Environmental Assessment Addendum

Replacement Flows Project - River-flat Eucalypt Forest near the M7

February 2009

ADDENDUM: FLORA AND FAUNA ASSESSMENT
FOR PROPOSED MODIFICATION TO PIPELINE
ROUTE – BELLS CREEK

Figure 1 – Pipeline alignment figure from EA

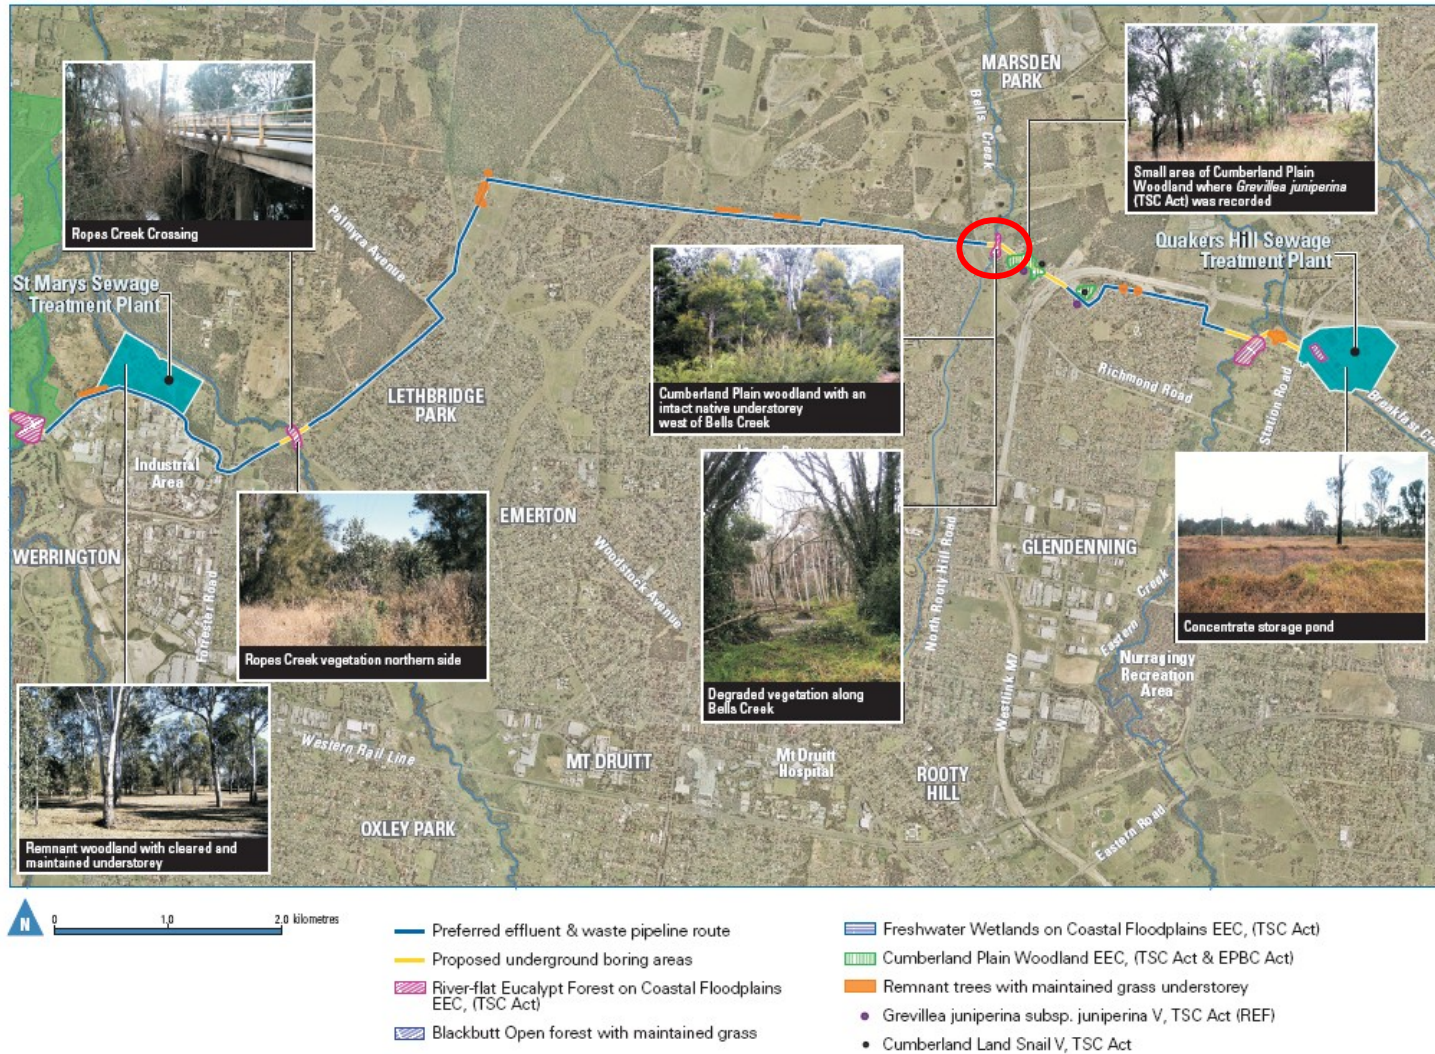
The original pipeline alignment joins a bore under an area of Cumberland Plain Woodland to the east and another bore under Bells Creek and associated River-flat Eucalypt Forest (See Figure 1) to the west. No direct impacts on River-flat Eucalypt Forest or Cumberland Plain Woodland were identified in the Environmental Assessment.

The revised alignment is approximately 20 metres south west from the original alignment. The pipelines pass through mostly cleared areas between a patch of River-flat Eucalypt Forest and a patch of Cumberland Plain Woodland. The pipeline is closer to the River-flat Eucalypt Forest. The pipelines will join up to a bore site located in a cleared area on the eastern edge of Bells Creek.

This revised alignment will require the removal of 4 trees belonging to the Endangered Ecological Community (EEC), River-flat Eucalypt Forest on Coastal Floodplains.

Plate 3: Cabbage Gum (*Eucalyptus amplifolia*) proposed to be removed labelled as “3” in Figure 1.

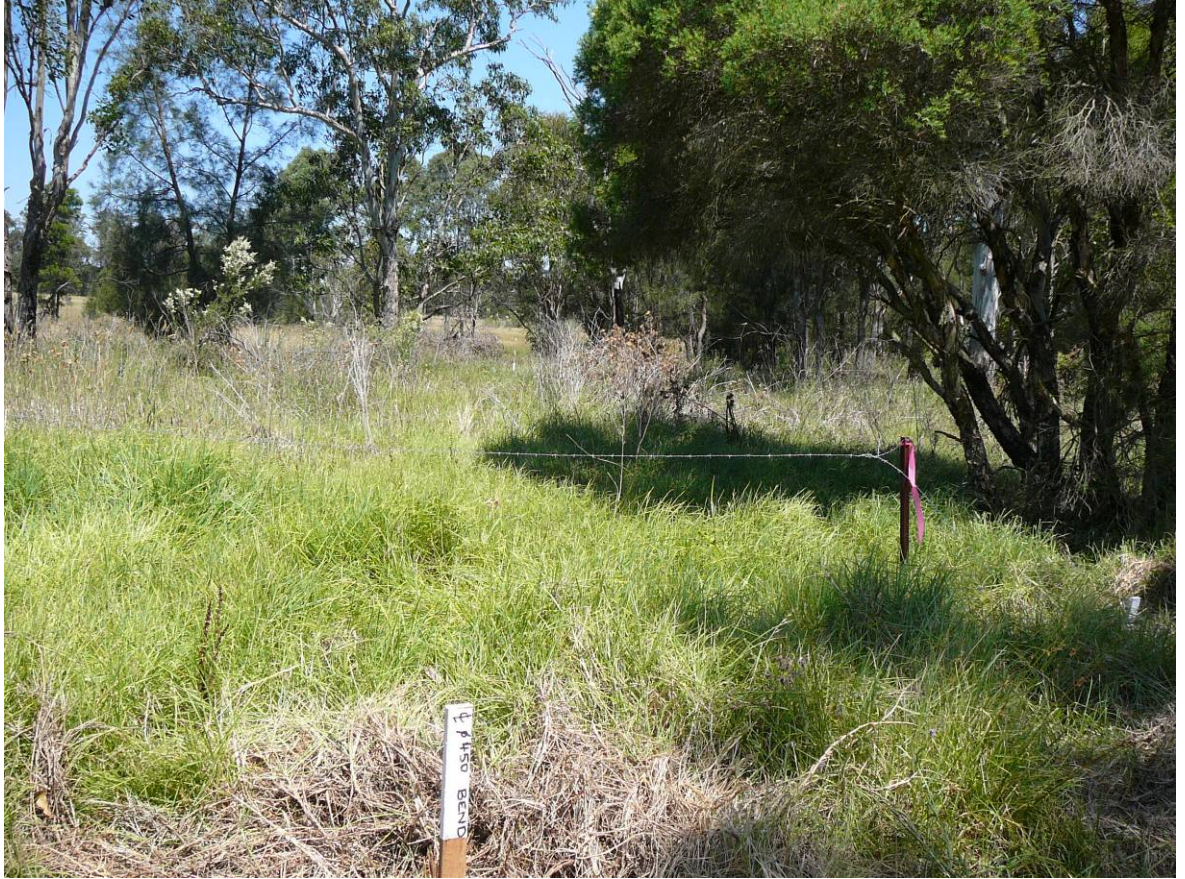
Plate 1: Photographs of Cabbage Gums (*Eucalyptus amplifolia*) proposed to be removed labelled as “1” in Figure 1.

Plate 2: Small Grey Box (*Eucalyptus molucanna*) proposed for removal, labelled as “2” in Figure 1
